IRON HORSE

A tensioning wheel bearing with a new type of rear drive wheel shaft has been introduced on serial nos. 0301399 onwards.

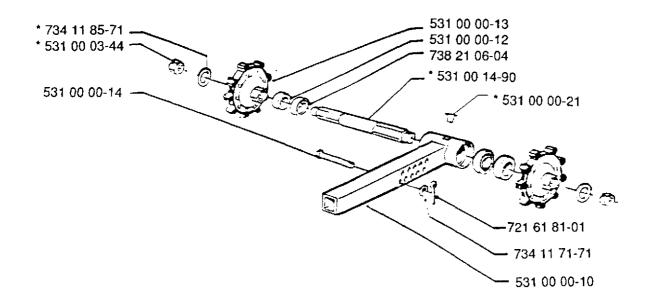
The new shaft is circular in section where it meets the ball bearing inner ring, in order to prevent dirt entering the bearing housing. On machines with the old type of shaft the sealing rings on the ball bearing become damaged when dirt enters the bearing housing. This results in the ball bearing wearing out unusually fast.

A plug has also been fitted to the hole in the bearing housing.
